A.P. - Munjoy -outh Project

July 22, 1966

I hereby permit you to construct 30 multi-family dwelling units as per plans and specifications at the above named location as being issued subject to compliance with the following:

THE LOCATION OF UNITS II + 14

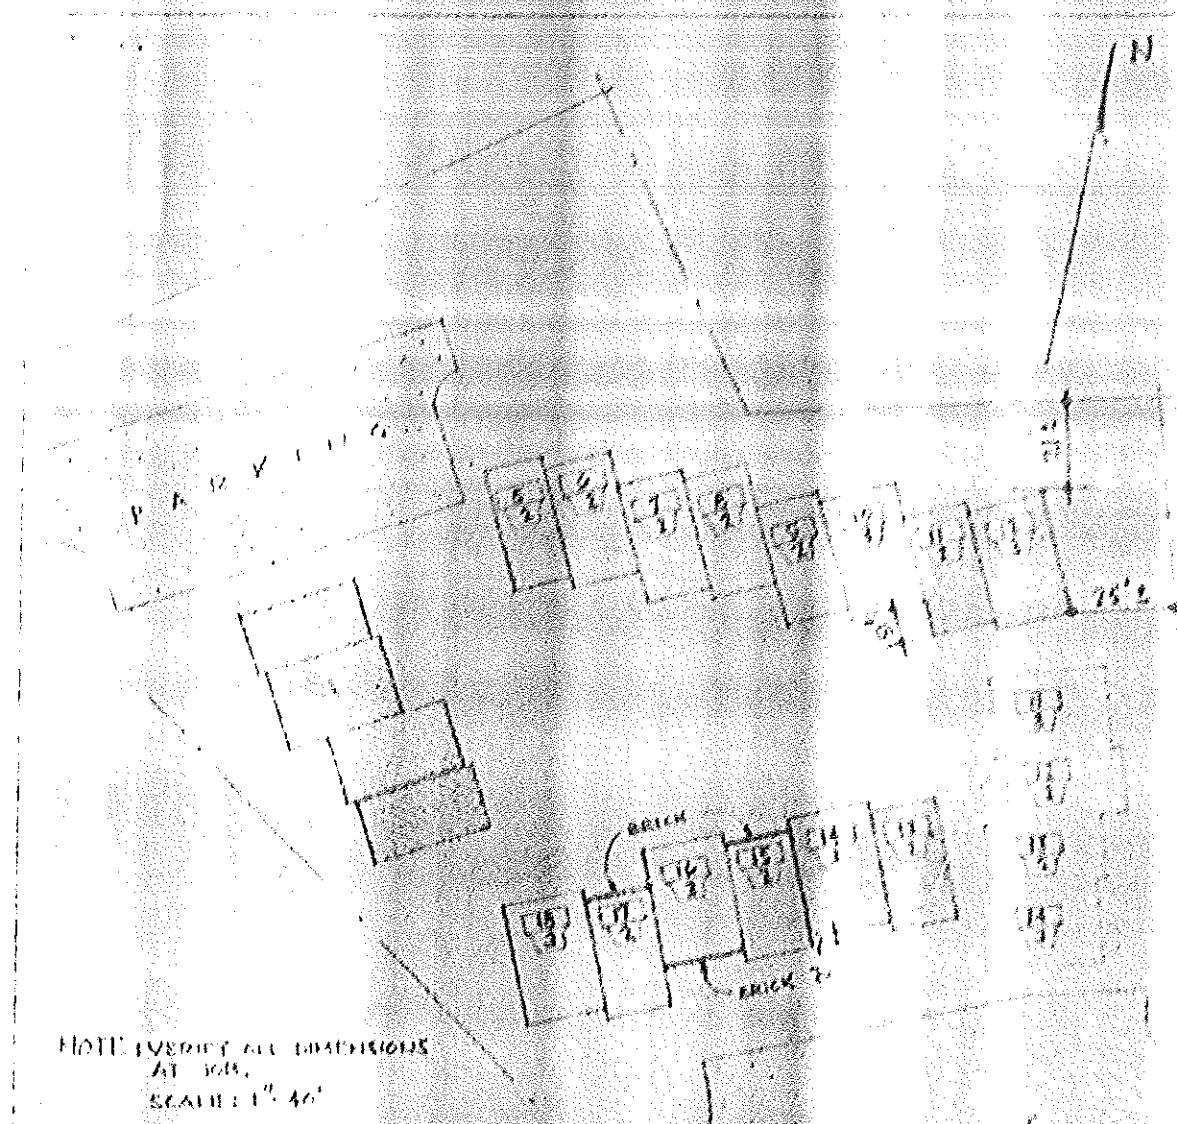
Add Units #13 and #14 to this building.
